Change Notice Information Announcement

RED Flag Notice

Product Name(s):	Mini Power-Zone Unit Substation	Customer Support No.:	1-888-778-2733
Product Line Description:	Bolt On Mini Power Zone	Document Issued:	11/17/2023

Example of Current Product MPZB15S40F	Example of New Product MPUB15S40F
---------------------------------------	-----------------------------------

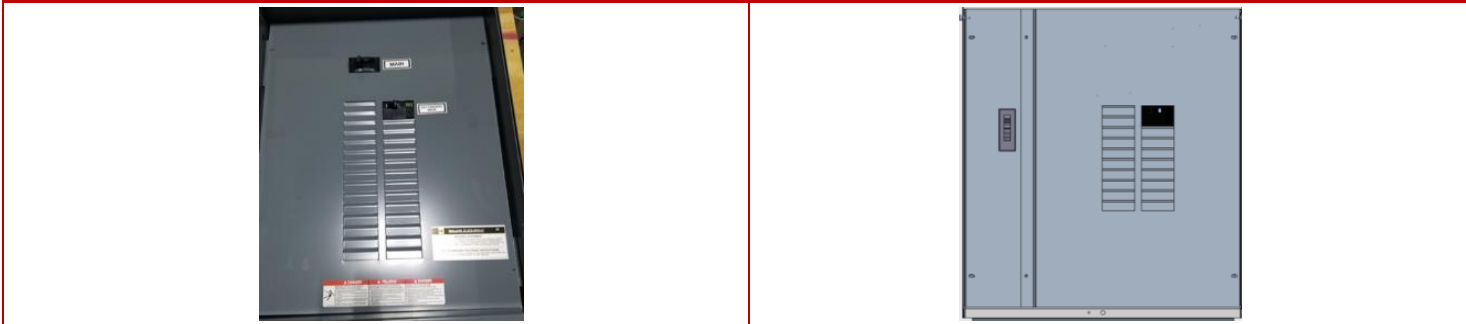
Description of Change:
 Schneider Electric is launching the MPUB, this new product will completely replace the current solution MPZB from Schneider Electric. **Originally announced February 2020 in association with the FAL breaker withdraw.** The MPUB product offering will incorporate the Power Pact H breakers, along with an updated NQ interior with incorporated neutral bar. It will also include the internal main breaker barrier first launched with the MPU solution, allowing for NEC service entrance requirements.

The new solution, MPUB has some small dimensionnel changes from the current MPZB offer. See the comparison tables below.
